**CITY OF MERCER ISLAND**

July 31, 2018

Re: Land Use Approval Letter for a Reasonable Accommodation Request  
Expanded driveway, walkways, and patio located at 6121 84<sup>th</sup> Ave SE Mercer Island, WA 98040;  
Parcel ID: 192280-0340

# Attachment B- Second Submittal Documents

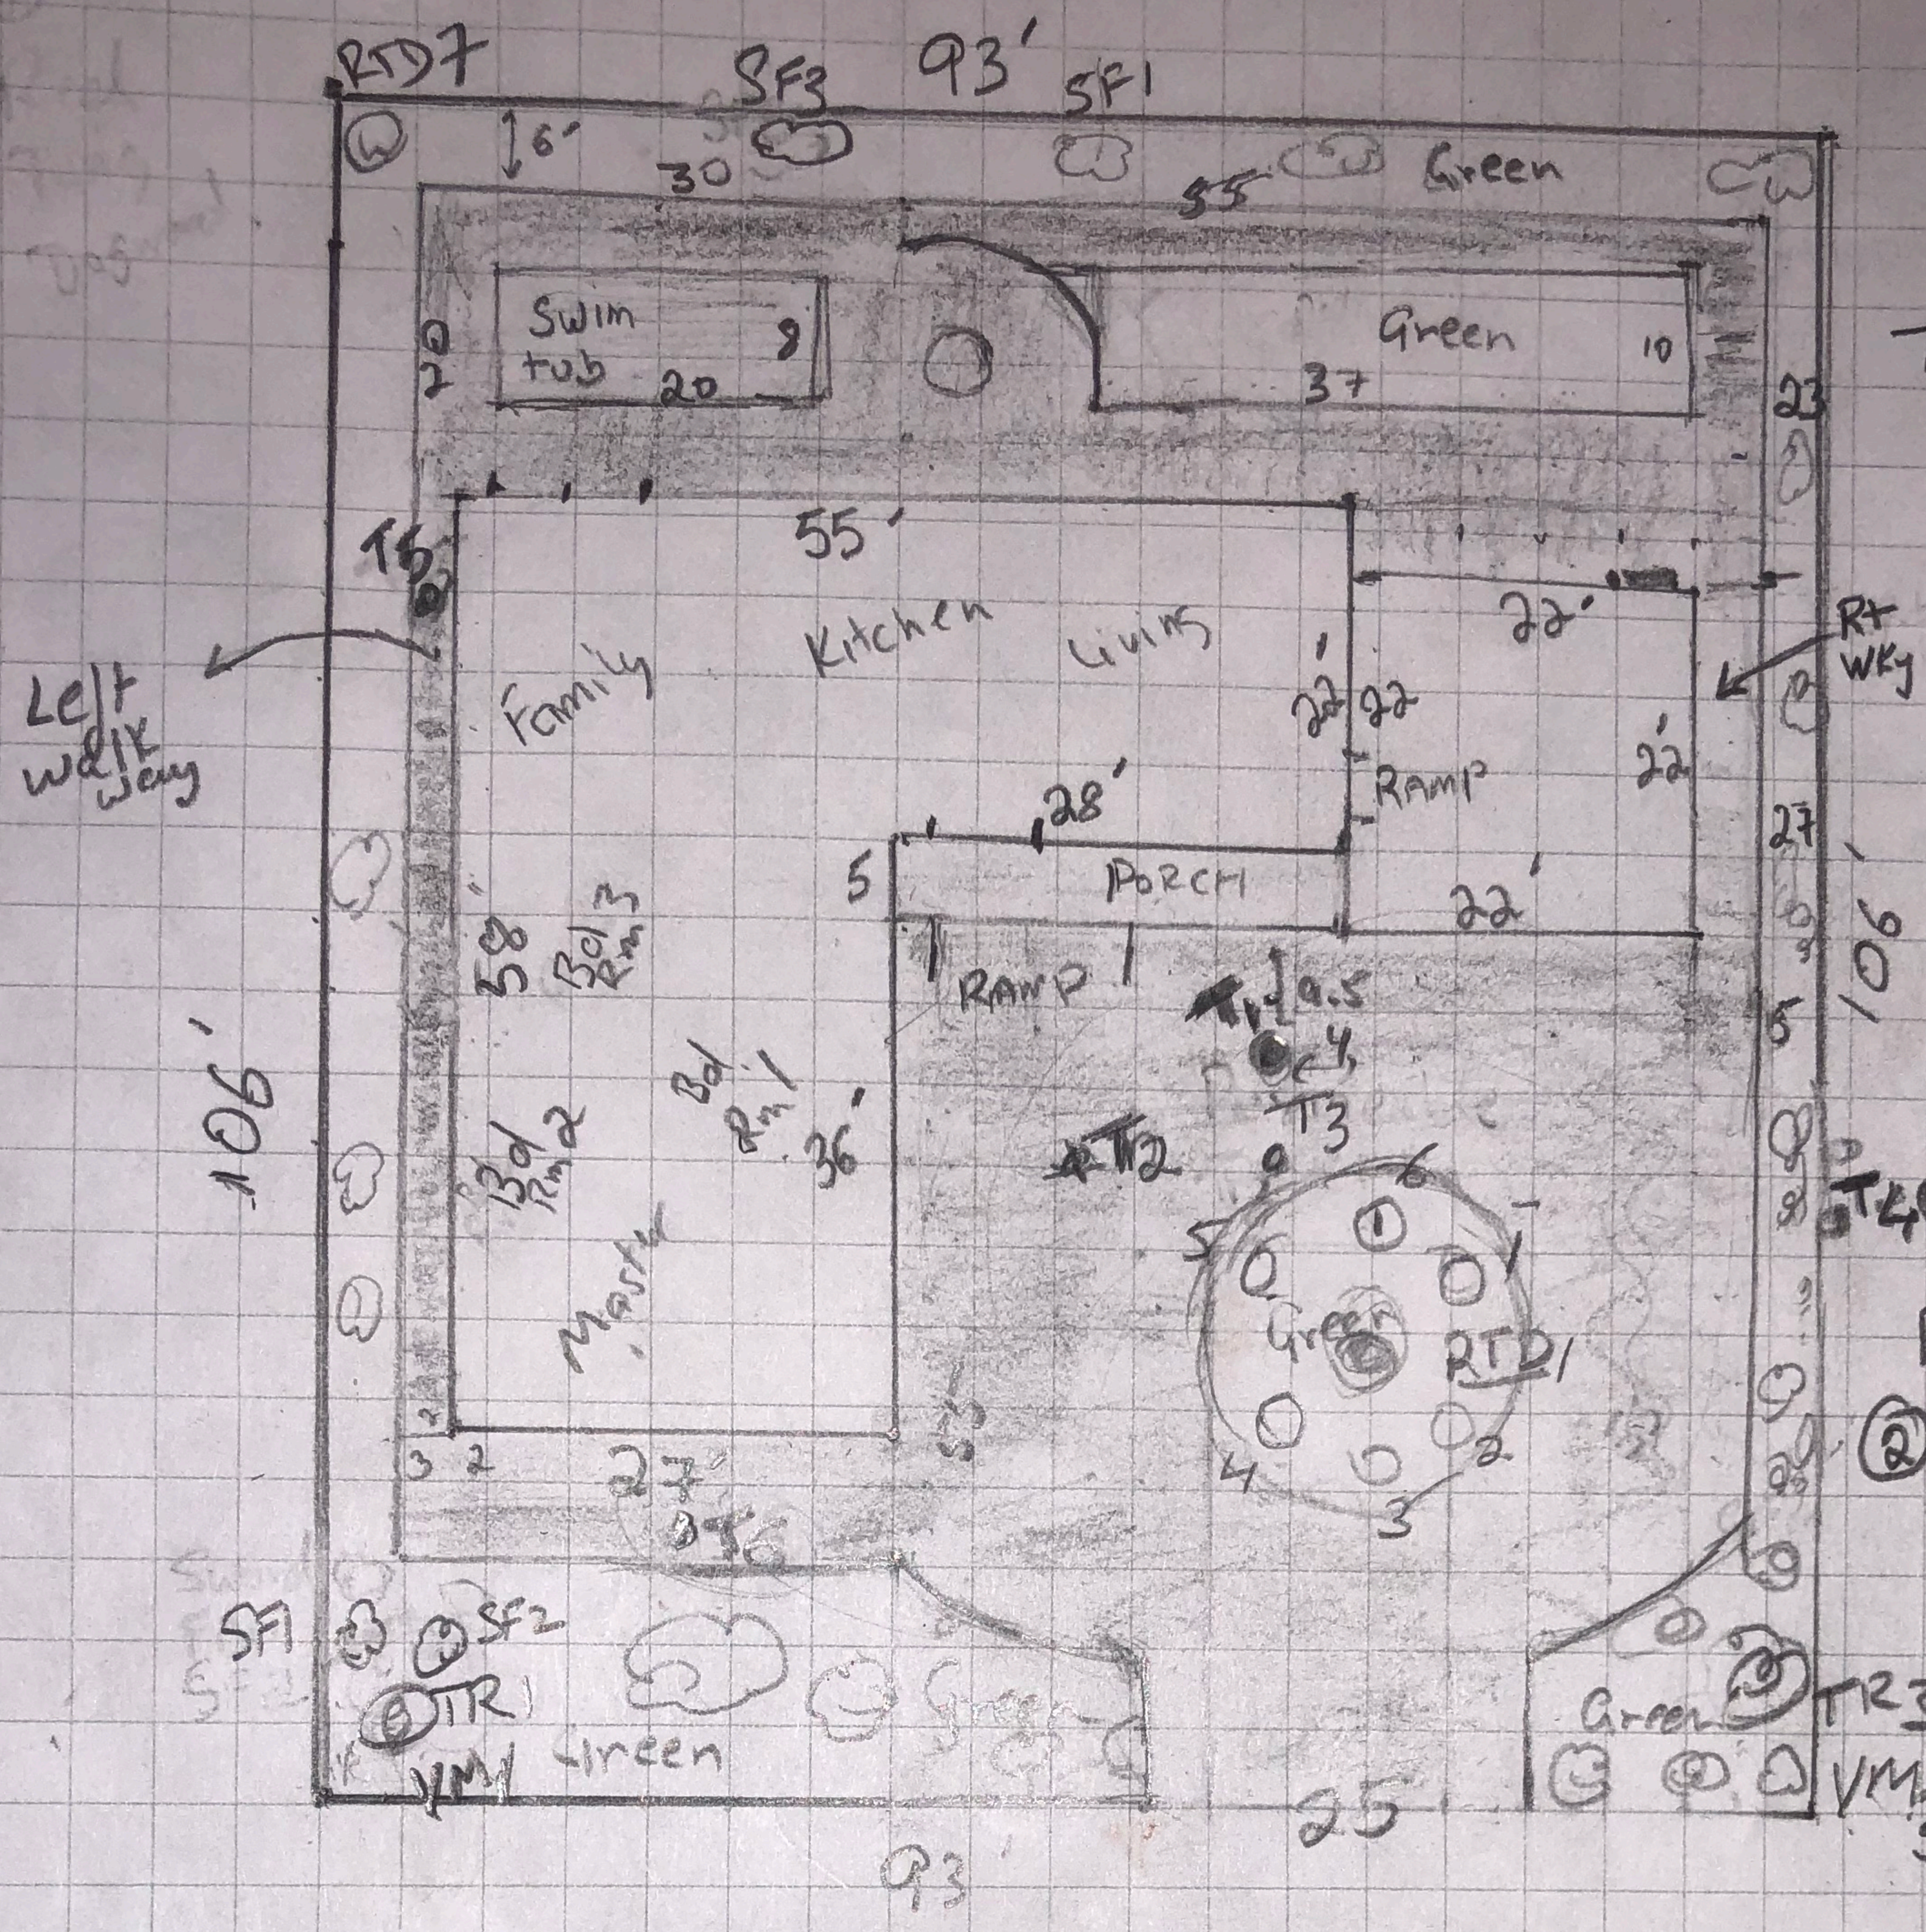
2. A landscaping plan is required, to mitigate for impacts resulting from the additional lot coverage and hardscape. Please provide additional landscaping information, that includes the following:

- a) A landscaping plan that specifies the proposed type of plants, species, location of plantings, and estimated quantity. Please note that native or adaptive species are preferred; and,

- b) A narrative how the plants provide a natural screening barrier.

Here is the updated plan. It is changed to Teardrop driveway.  
Overall driveway is now reduced from 1950 sq ft to 1698 sq ft.  
This reduces the over all total to 68% of hardscape which is 12% for special consideration.

We have consulted a local landscape design and we will be able to save one of the native Vine Maple tree (marked T2).  
Overall we will have following native plants at the marked locations

1. Vine Maple ( Total 3 of which one is relocated from T2) (marked as TR1, TR2, TR3)

1. Red Twig Dogwood (Total - 7 marked RTD 1,2,3,4,5,6,7 - 6 in center circle and one behind left corner)  
2. Sword Fern ( Total - 3 - marked SF1,2,3 - 2 in front left with TR1 which is relocated T2 - Vine Maple and one in left back yard.

Trees Removed  
T1, T3, T5, T6

Tree Relocated  
T2 → TRI (VM)

Special Consideration  
= 6762 - 5323 = 1439 sq ft  
= 6510 - 5325 = 1187 = 14+5%  
= 12%

Driveway - 1 + 950 sq ft  
 $(15 \times 55) + (15 \times 20) + (15 \times 55) \rightarrow 1698$   
 $(55 \times 35) + (375) - 602.8$

# Attachment C- Existing Fence Photos

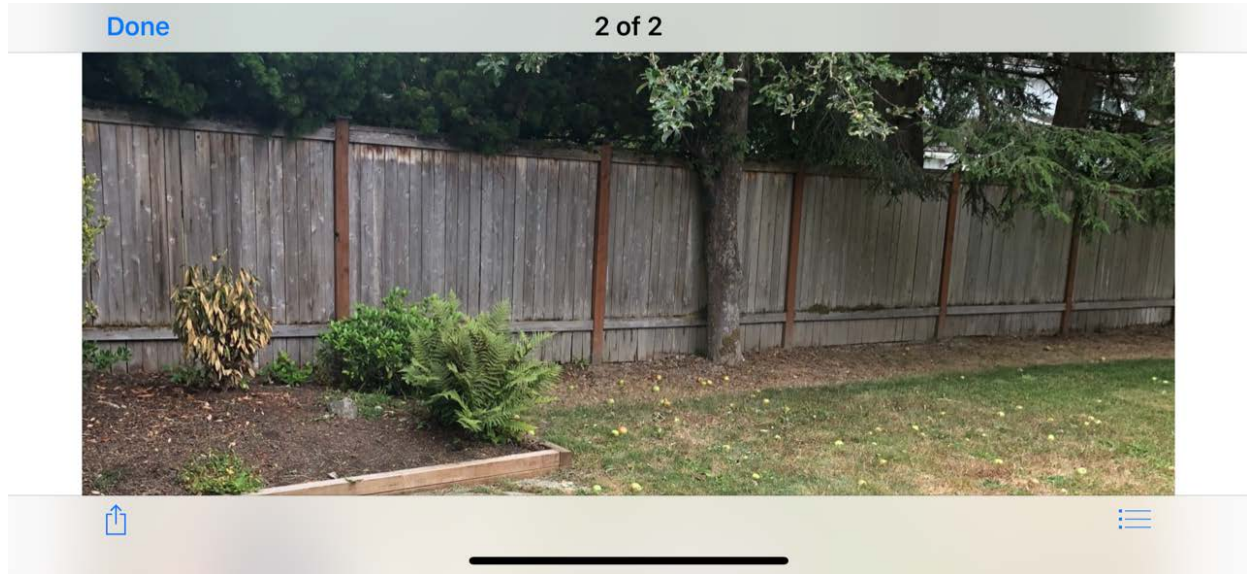
The applicant has provided a planting plan with native species to mitigate the impacts from the additional lot coverage and hardscape. The vegetation acts as a natural buffer. Please refer to Attachment B for the planting plan. In addition, there is an existing backyard fence that provides ample screening. Please refer to Attachment C for photographs of the existing fence. Staff finds this procedure has been met.

I also wanted to let you know our backyard is completely fenced to provide the screening.

I have attached a picture of the fence.
